ENGINEER'S SUPPLEMENTAL INSTRUCTIONS NO. SIXTEEN (16)
(Via Posting to FTP Site and Electronic Mail)

RE: Harold D. Thompson Regional Water Reclamation Facility (HDTRWRF)-Phase 1
ENGINEER'S SUPPLEMENTAL INSTRUCTIONS NO. SIXTEEN (ESI-016)

This ESI-016 is being issued to provide additional information on underslab piping to the wet wells of the Pumping and Disinfection Building. The previously issued Drain and Vent Plan, Sheet PD-17, has been revised to include additional information on the A-Basin Drain pipe and the Headworks Wastewater/Drain pipe coming into the wet wells. The information given on this drawing will allow construction of the pipelines to 5 feet outside of the building foundation. Please note that pressure testing of these pipelines will be required and must be incorporated into the construction schedule.

COORDINATE LISTS II
HAROLD D. THOMPSON REGIONAL WATER RECLAMATION FACILITY
LOWER FOUNTAIN METROPOLITAN SEWAGE DISPOSAL DISTRICT

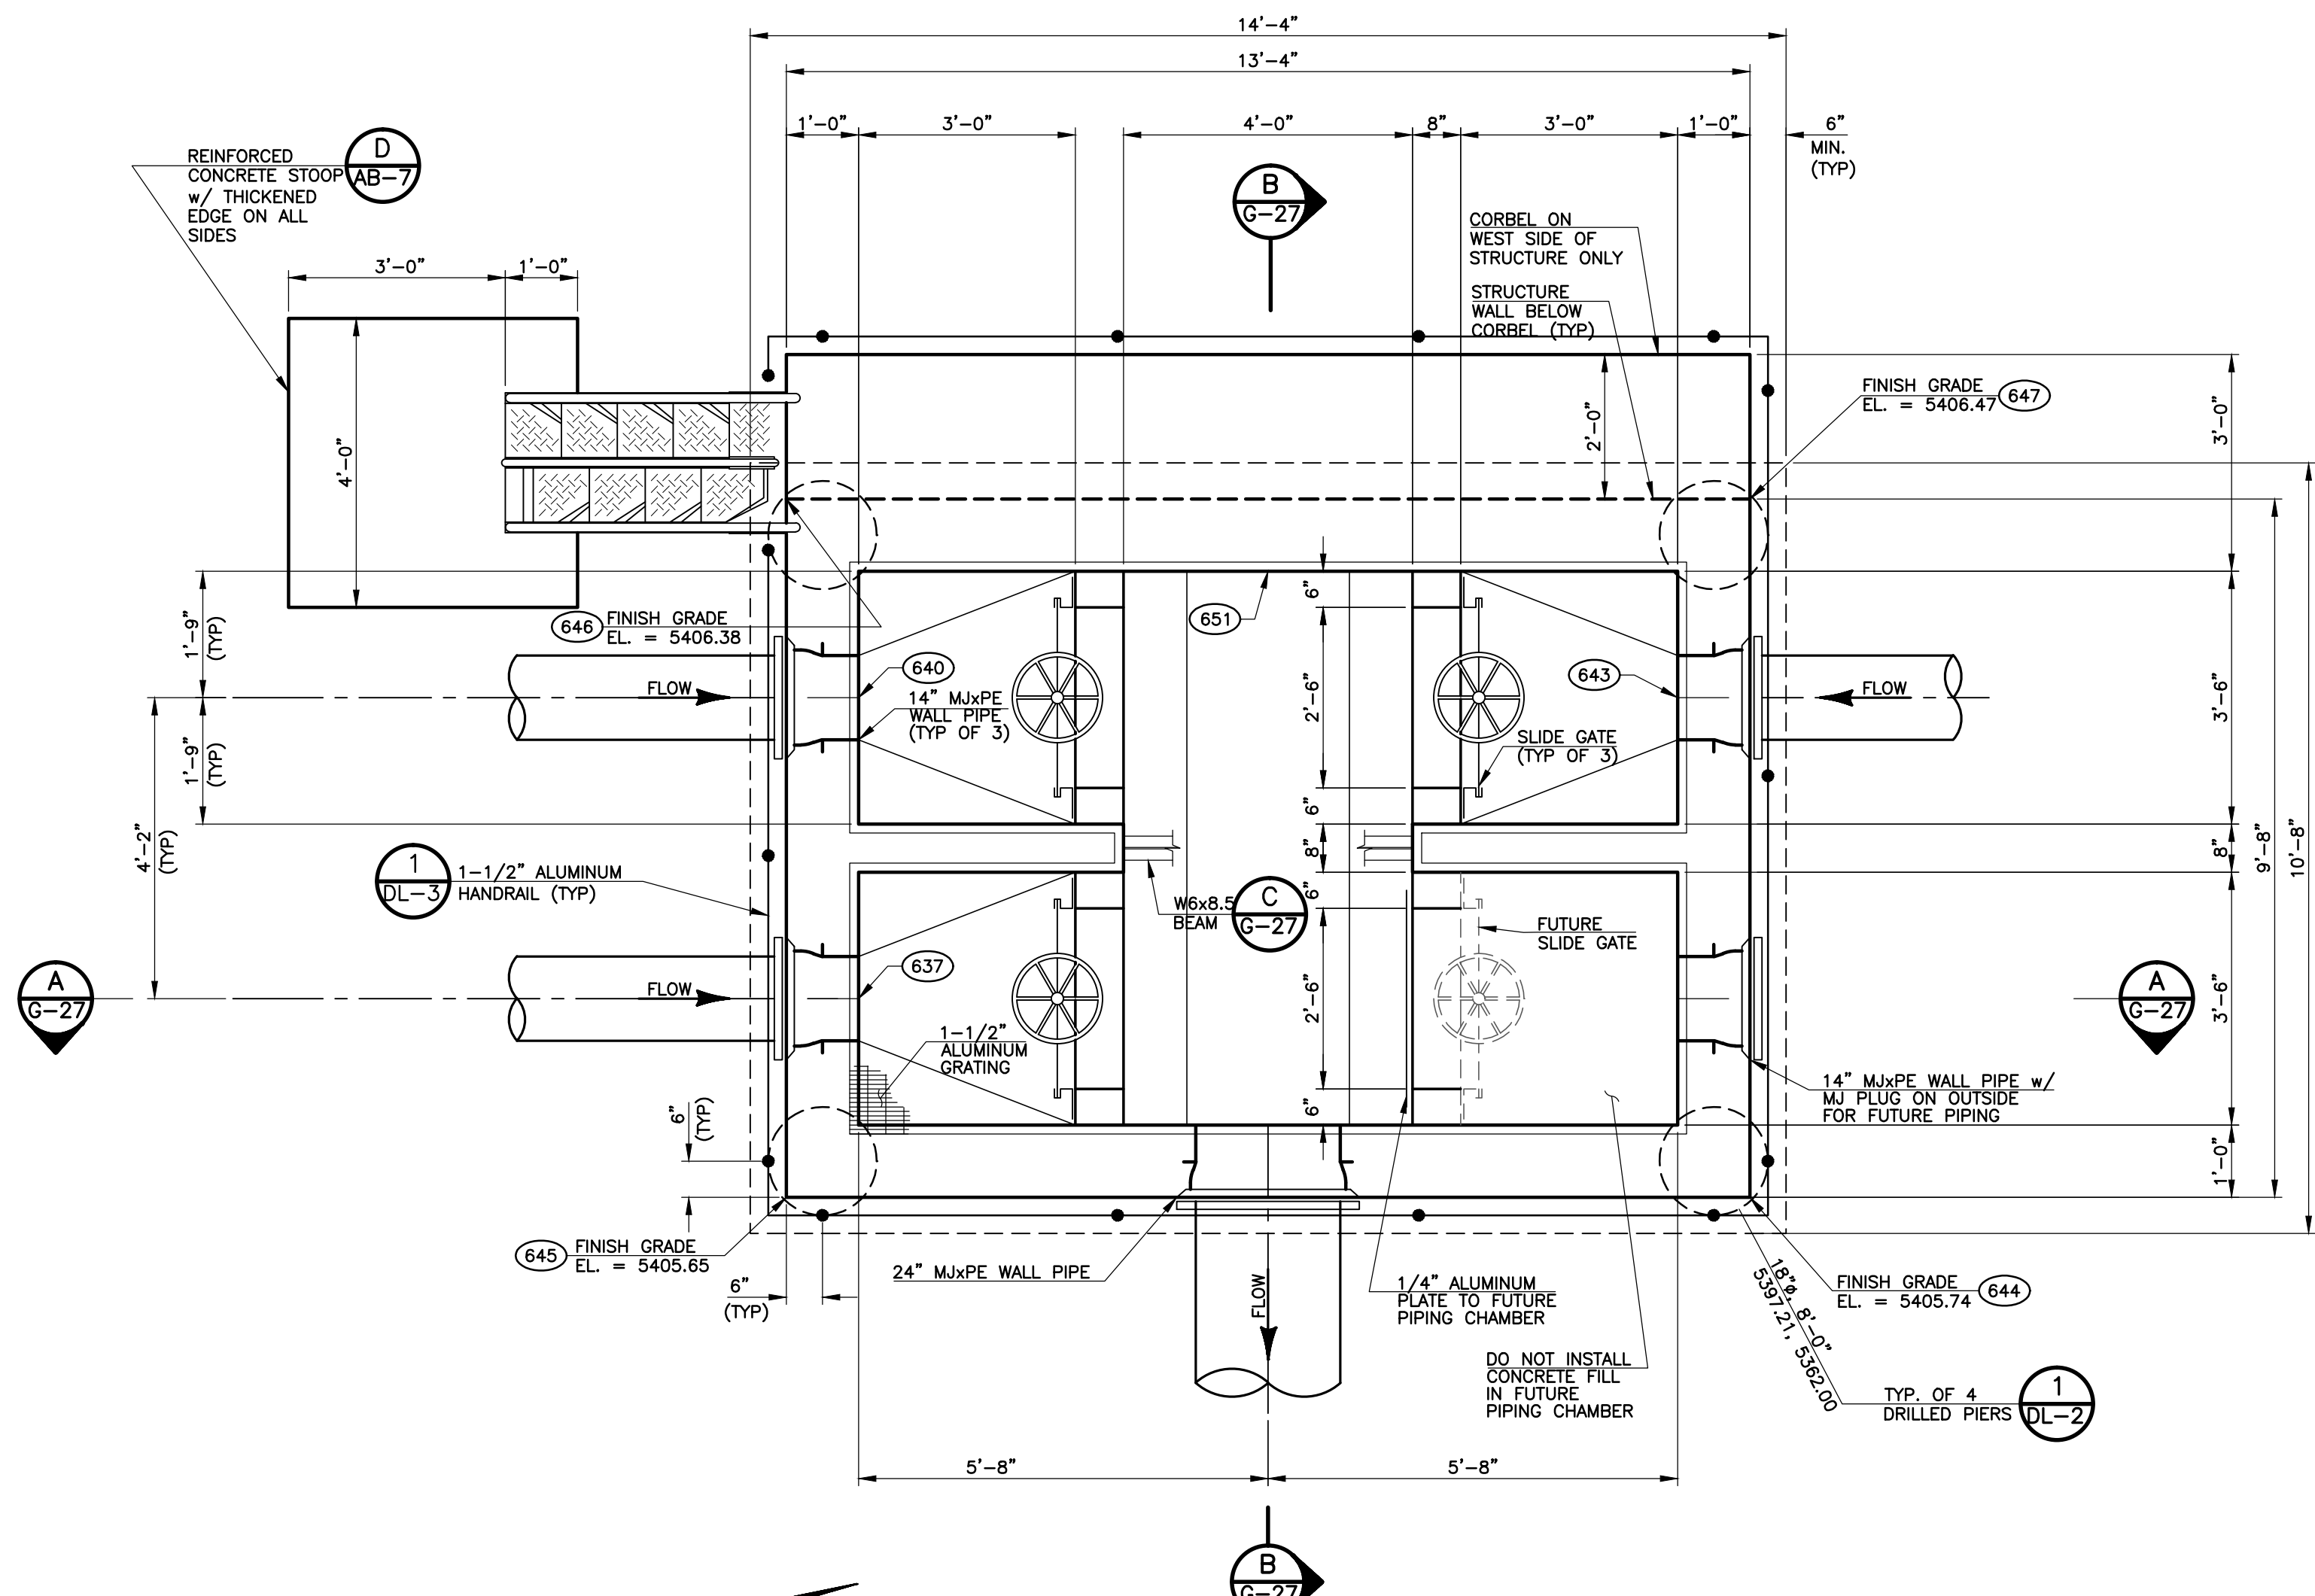
This ESI-016 also includes an in-progress drawing for the Aeration Basin level control structure, Sheet G-27. This in-progress drawing is being issued for drilled pier construction data only. All other information is considered in-progress information and is not to be used for construction. However, it is requested that WCMI prepare a Request for Contract Modification Order (RFCMO) for this structure based on the attached Sheet G-27. For construction layout of the drilled piers associated with this structure, a revised Sheet G-3 – Coordinate Lists II is attached as well.
